Item #	Quantity	Description	Unit Price	Extended Price
<p><u>ADDENDUM NO. 02</u></p> <p>Project Name: R2501725 - Shock & Awe Stormwater Improvements Phase I Marshall University Huntington, West Virginia</p> <p>Purpose: Modify Bid Opening Date and Time, and Respond to Vendor's Technical Questions.</p>

Technical Questions and Answers Addendum 02
R2501725 Shock & Awe Stormwater Improvements Phase I

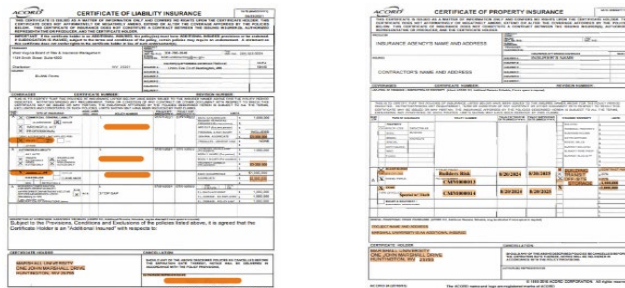
Q18. Regarding the HDPE lining for the 15” pipe mentioned in key note 4 on “Site Plan”, would an approved equivalent be accepted? Such as cement mortar lining or epoxy coating?

A18. See Addendum #1, Part 3 – Changes to Specifications, B, and Part 4 – Changes to Drawings, A.
